**COOK INLET HOUSING AUTHORITY
TYONEK TERRACES**
Anchorage, Alaska

*Kramer Electrical
Red Line Drawings*

NAME OR TYPE OF PROJECT
Tyonek Terrace
Electrical

TYPE & DATE OF PLANS
As-Built
September 15, 2003 34x26 26 Pages

SHEET NO.
E2.5

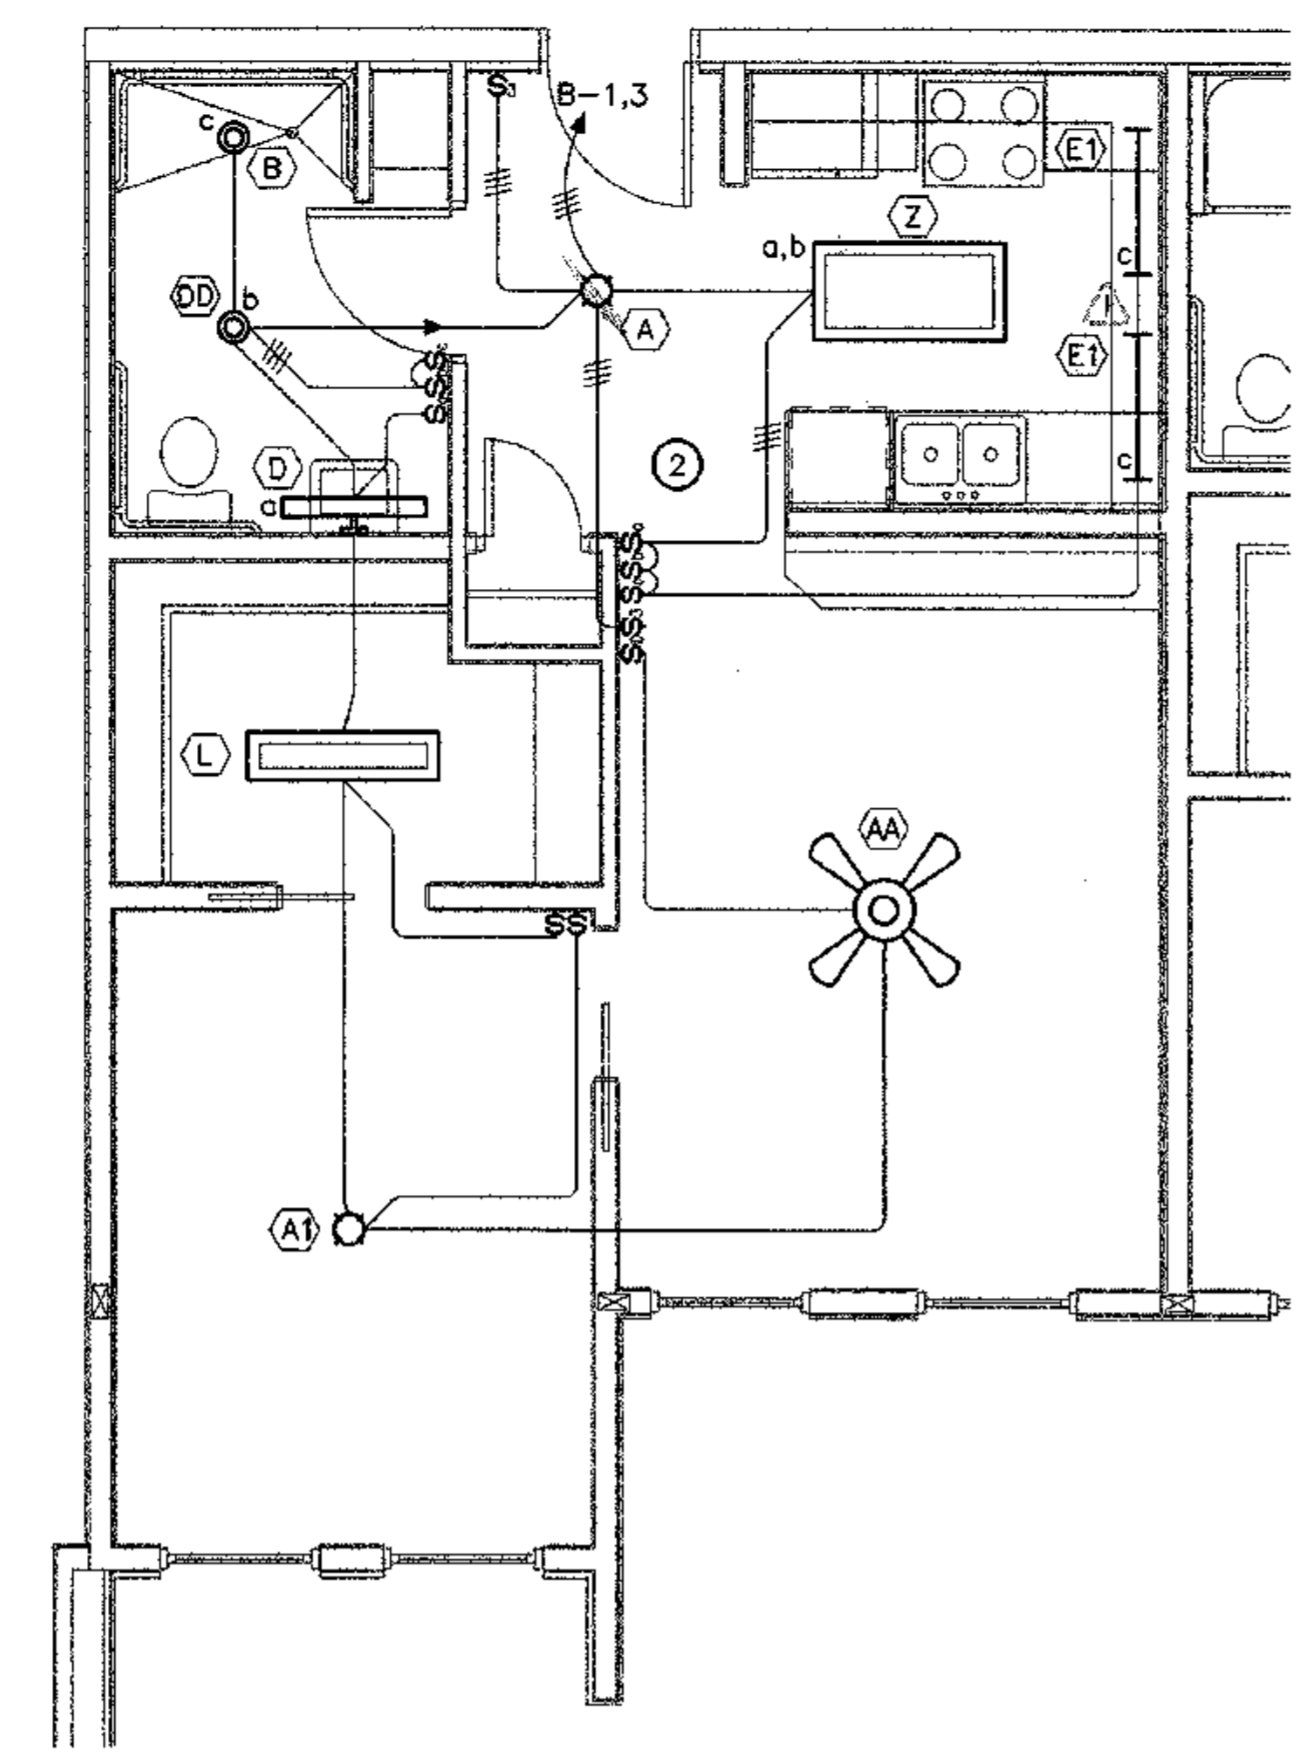
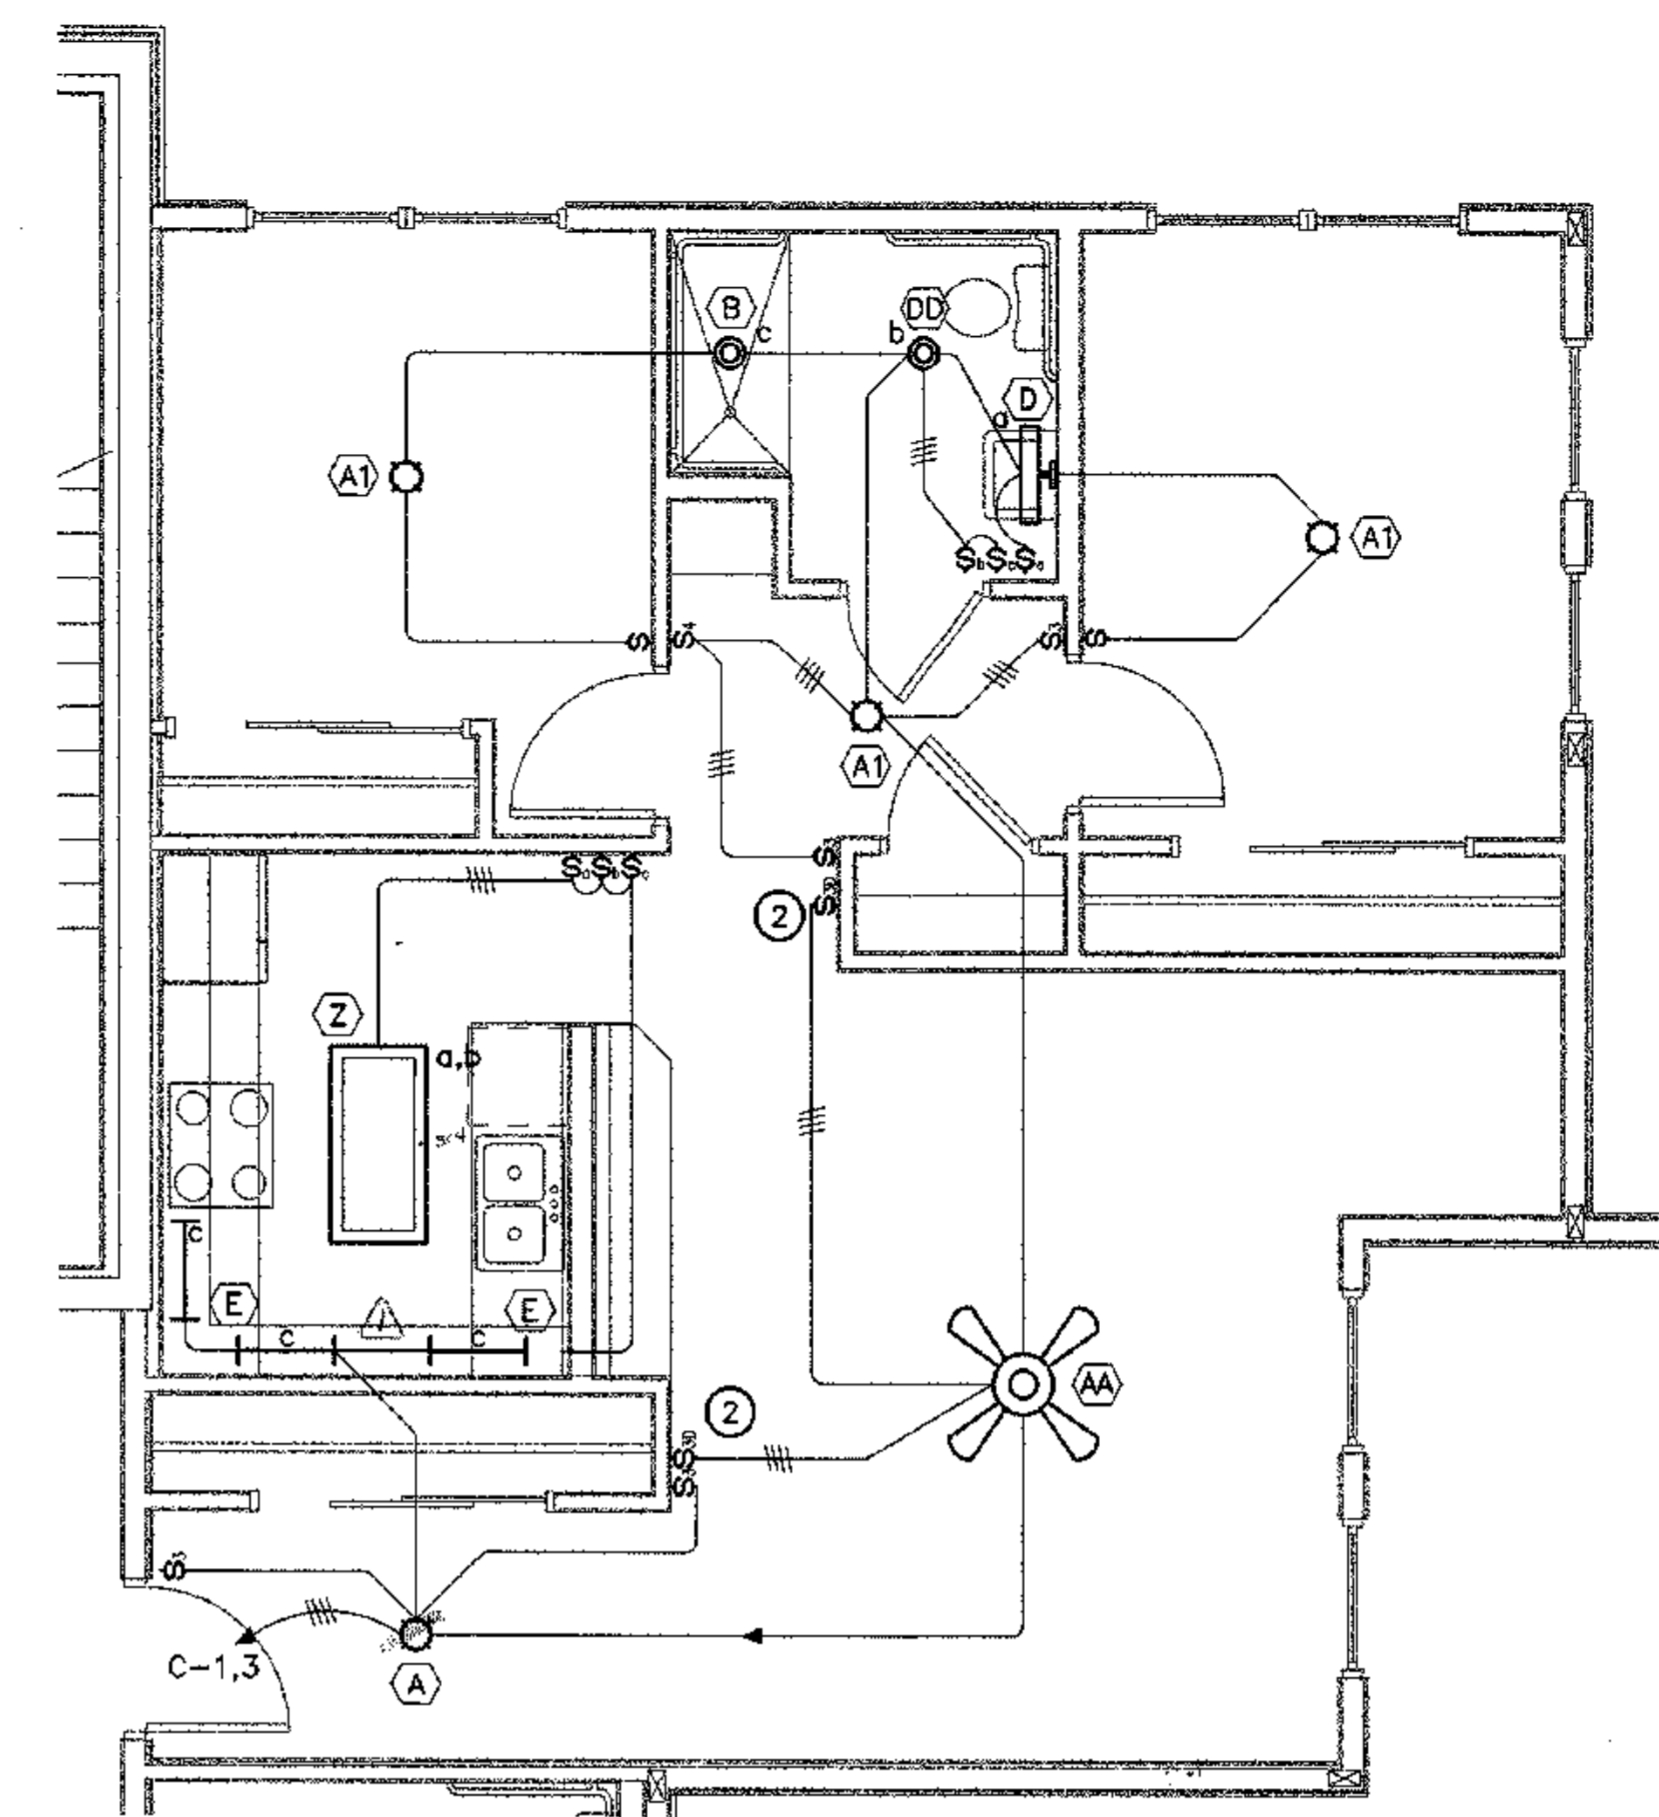
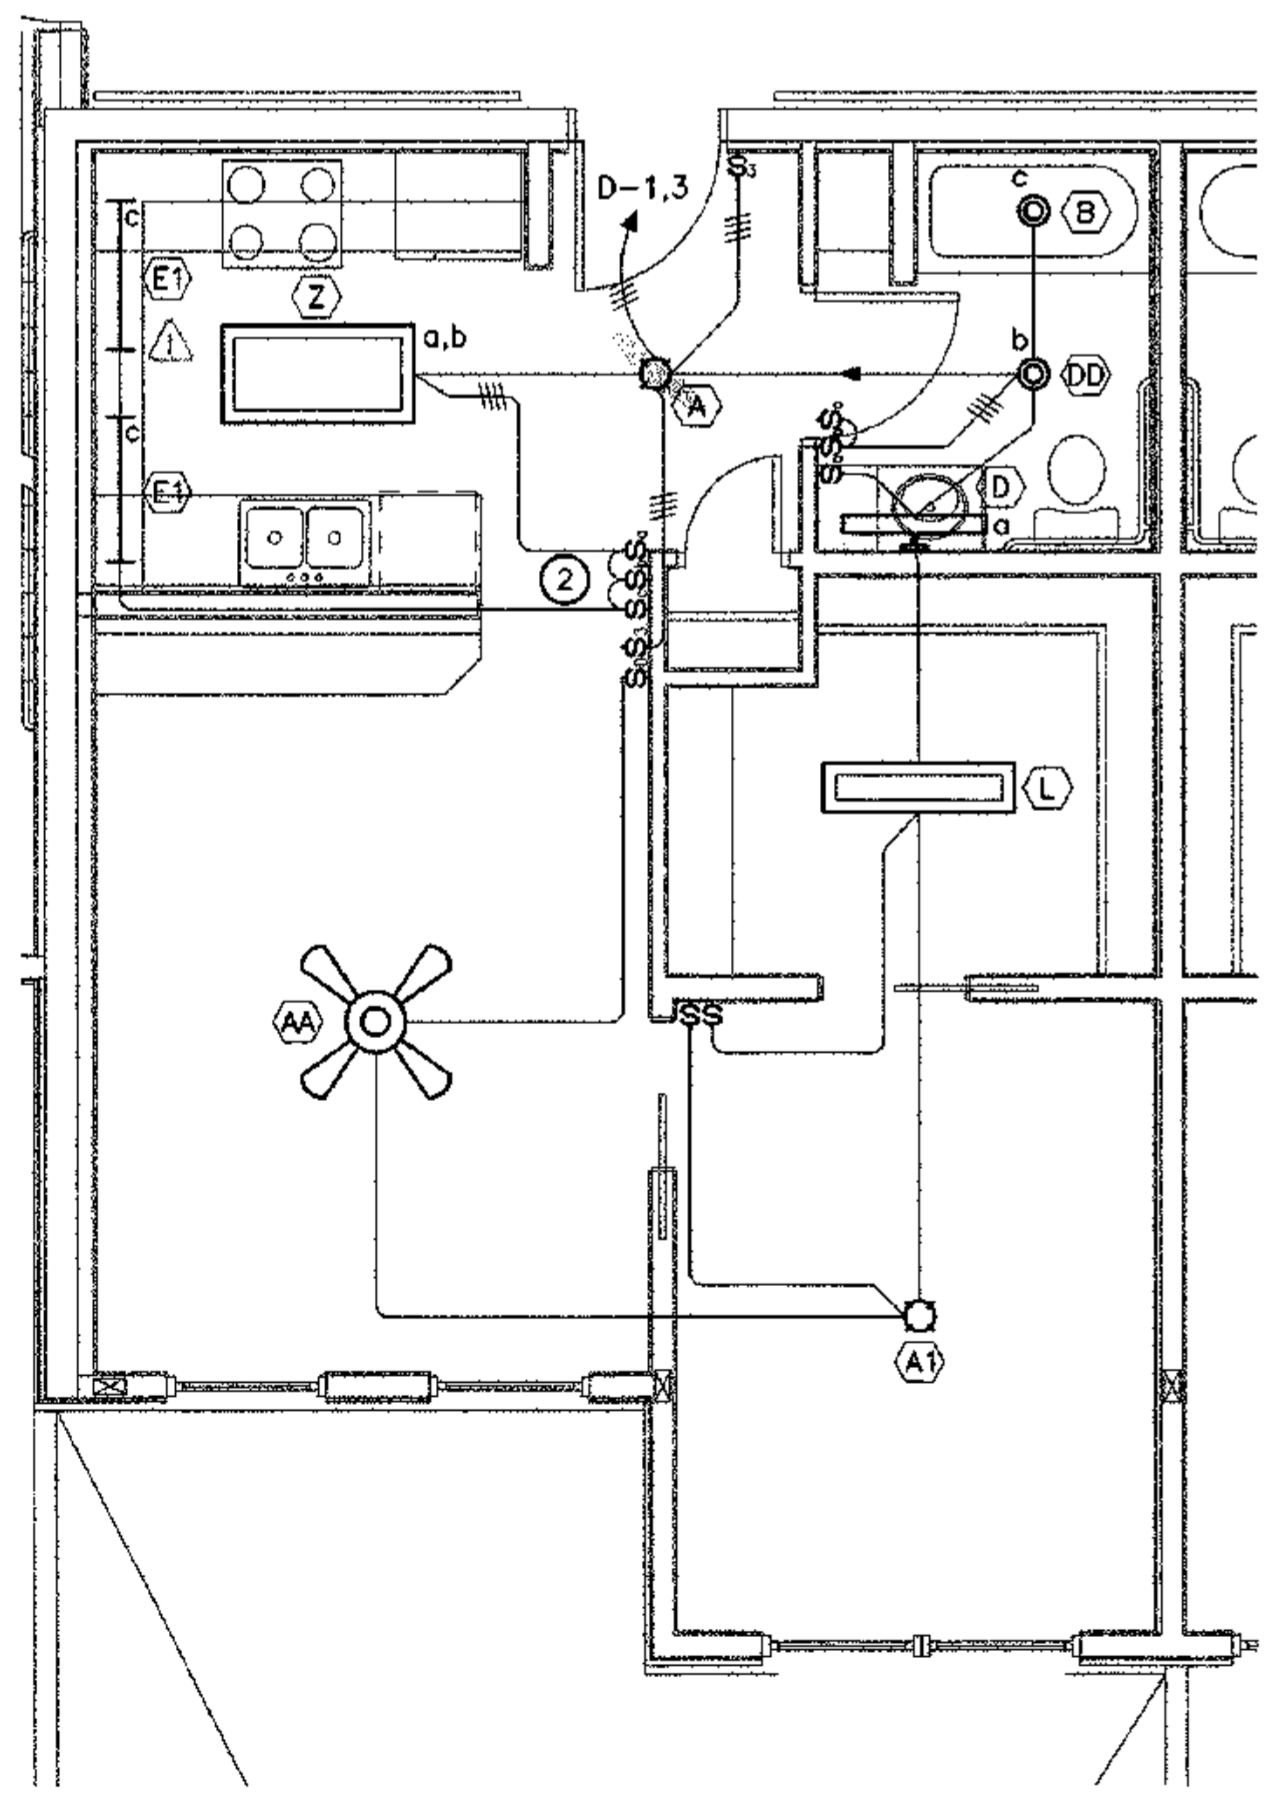
⚠ Under Cabinet Lighting Has Been Eliminated (Refer To REF # 22)
